KMR.CDD.MaQ.1922.02

RE:BUILDING ON PLOT NO.81.SHEET NO. C-6.

RE: PROPOSED BUILDING ON PLOT NO. 81, C-6.

AMENDED PLAN

PLAN OF GROUND FLOOR

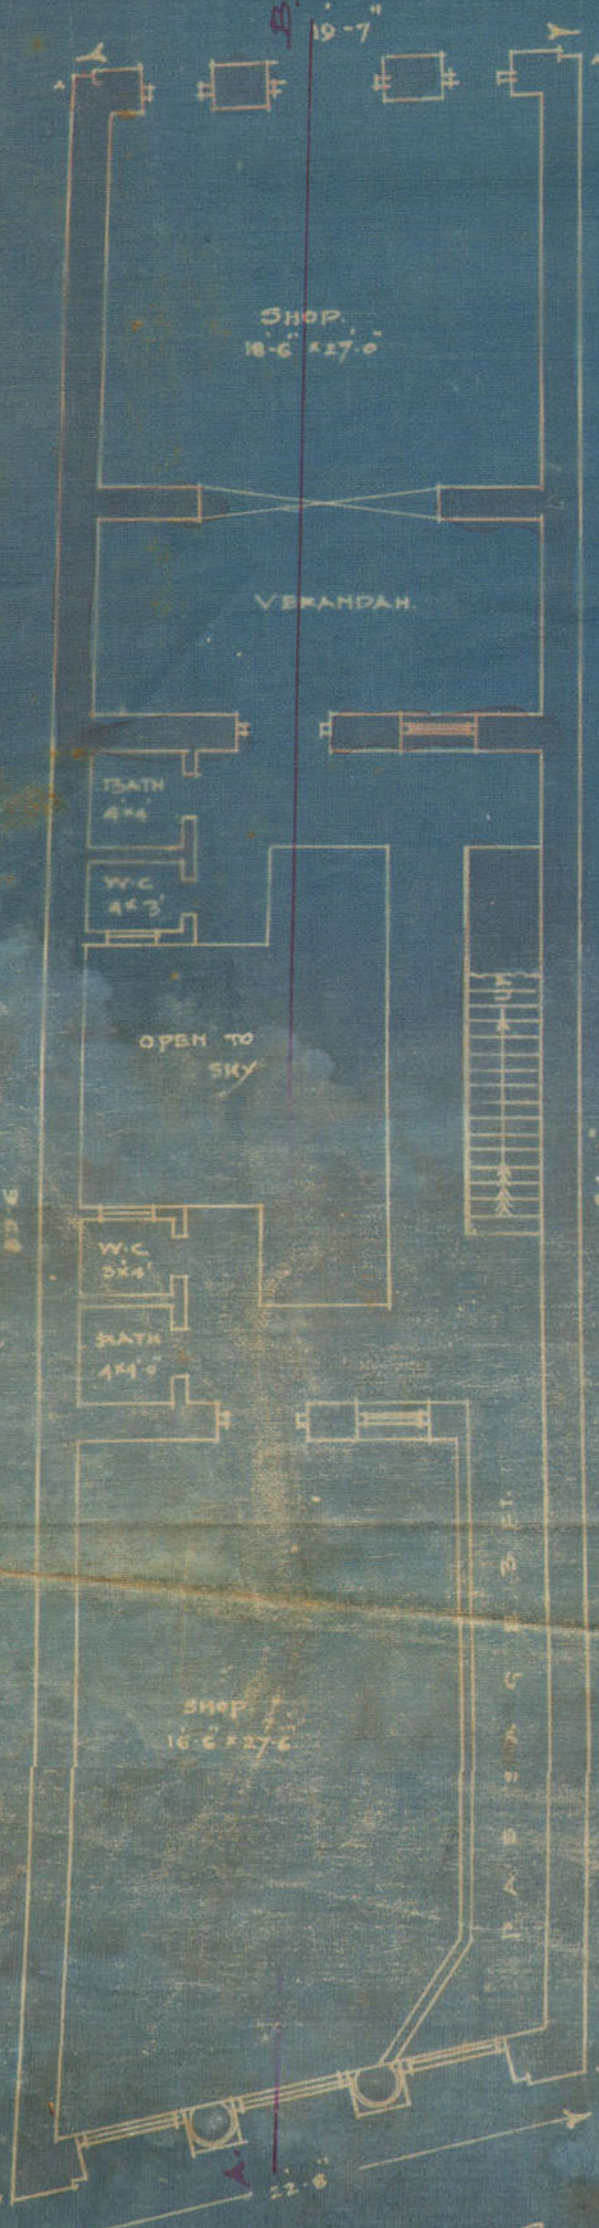
- (1) The access to the stair-case is provided from the Bunder Road instead of from the Marriot Road.
- (2) The position of the bath & w.c., is changed from the east to the west.
- (3) The front elevation has been revised.

FRONT ELEVATION

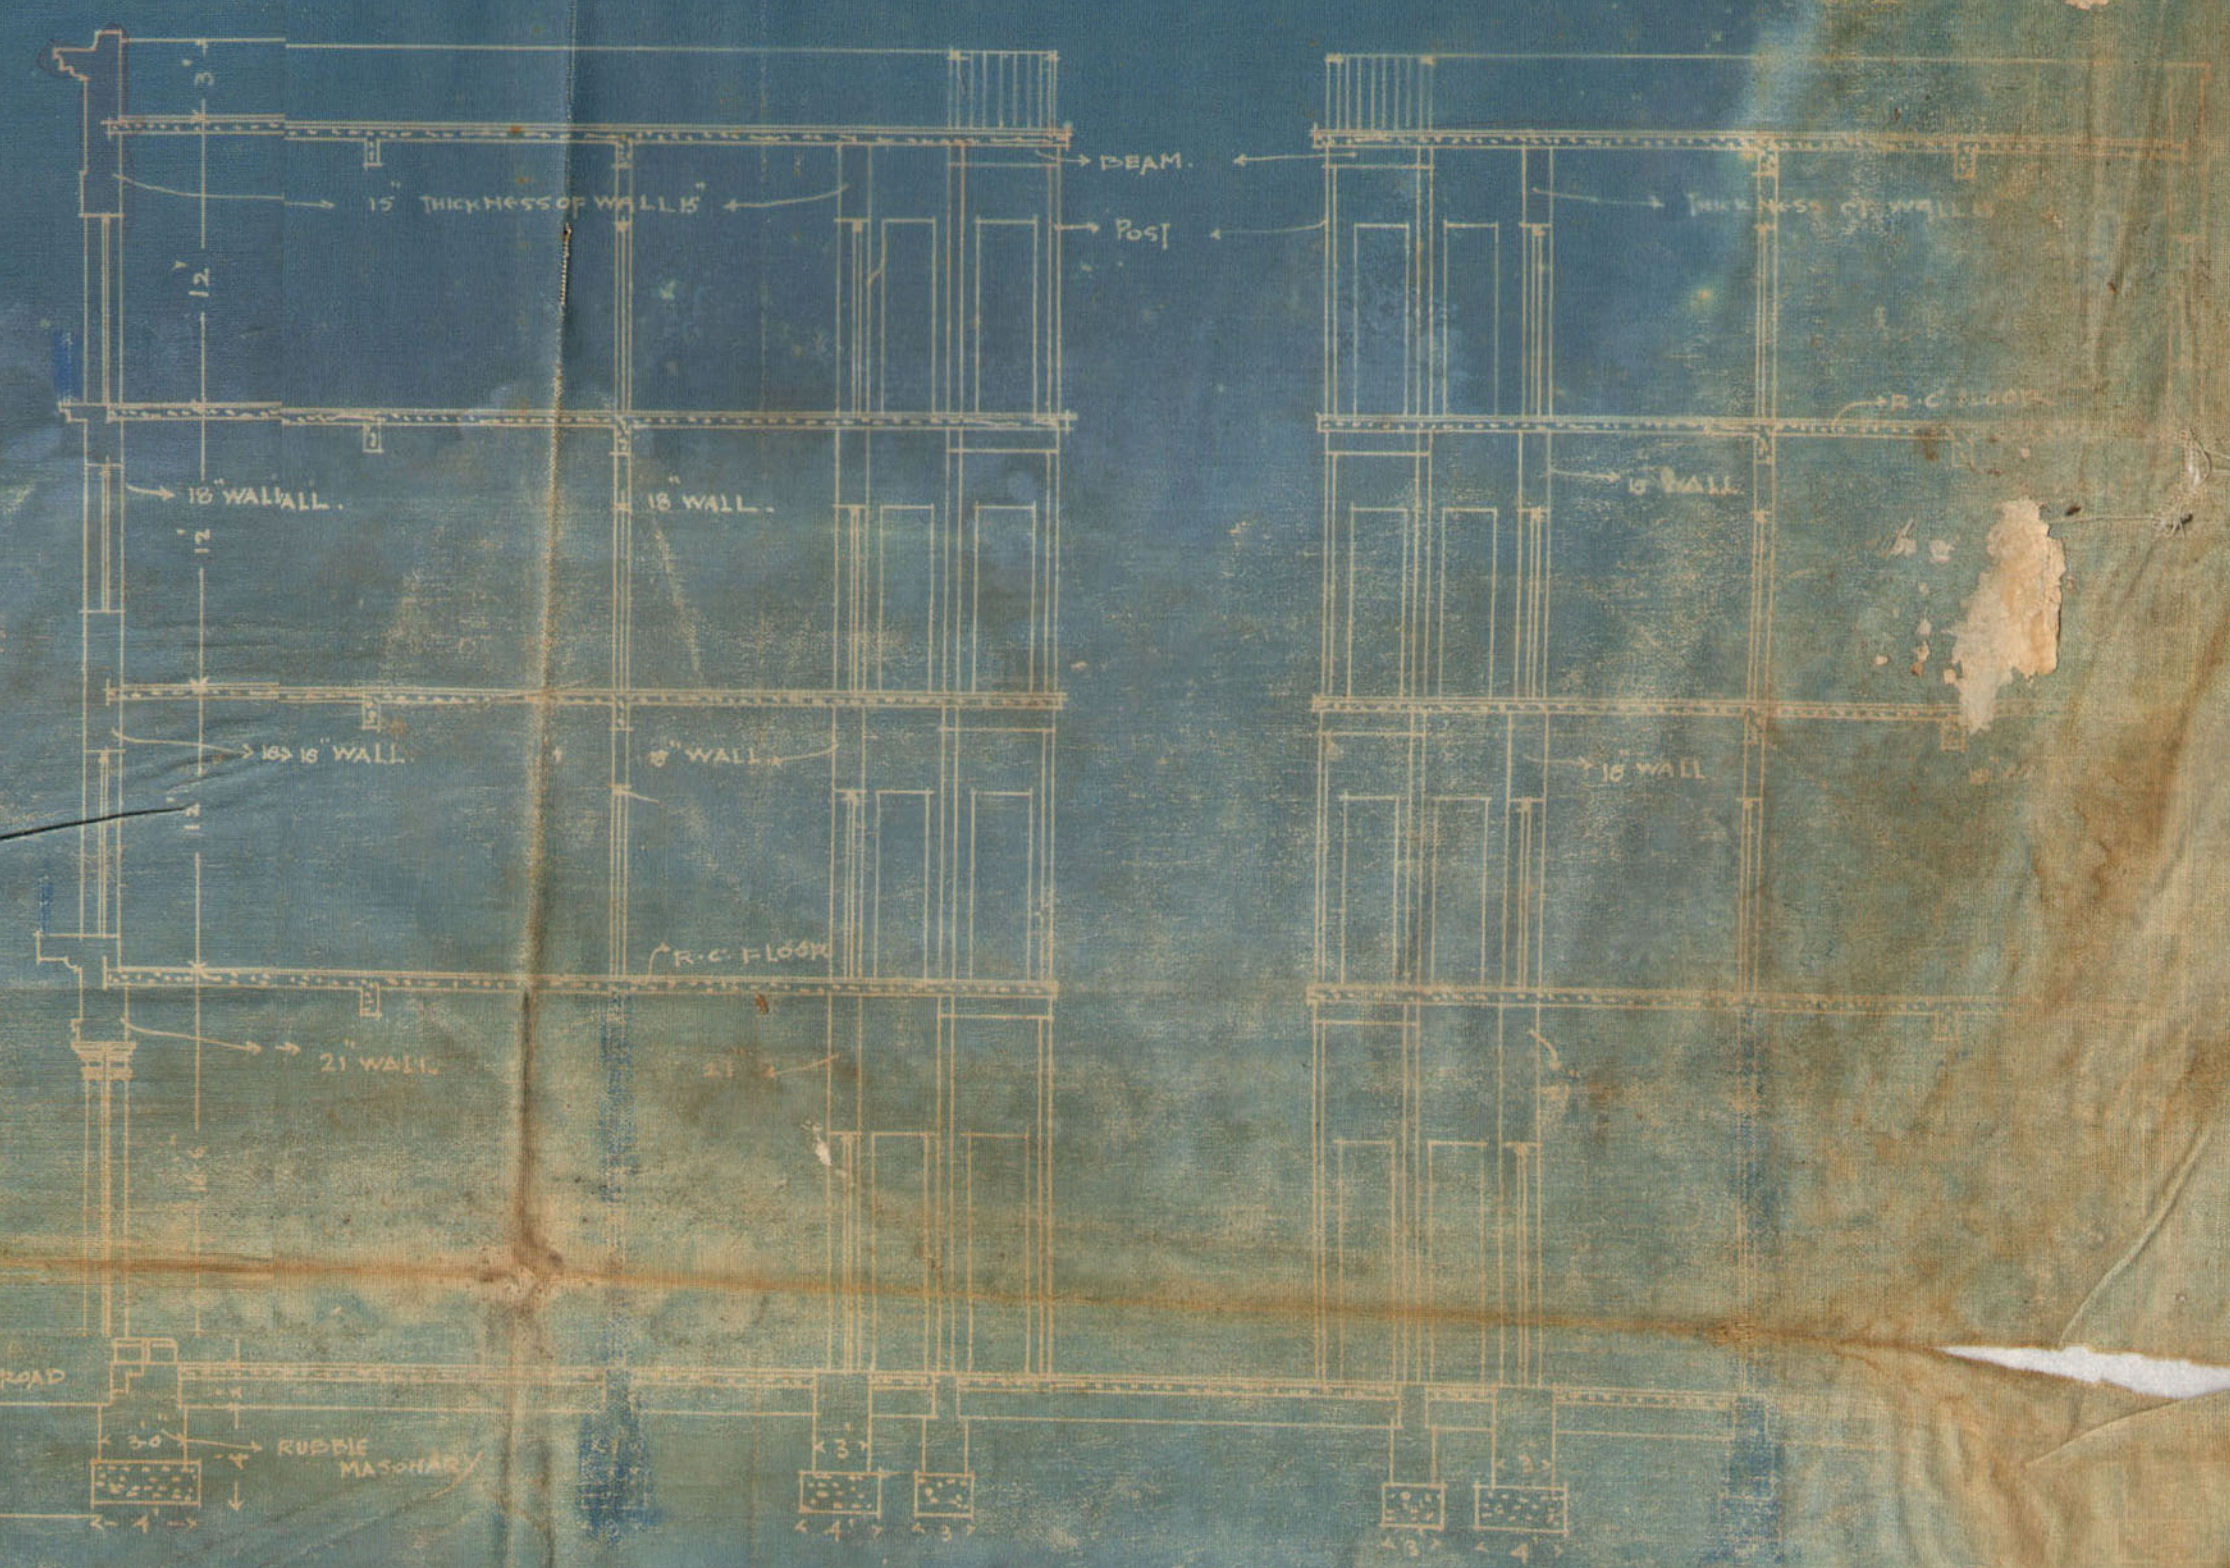
There are no balconies on the first floor; and those shown on the 3rd floor will consist of railing on the projection of the cornices, which will not be more than 12". If special permission is required for the same, we shall do so.

The section line is shown on the plan and the foundation width for main walls is increased to 6'-6".

The height of the adjoining buildings is shown on the plan, and the detailed drawings of the REINFORCED CONCRETE FLOORING will be submitted in course of time before doing the work.
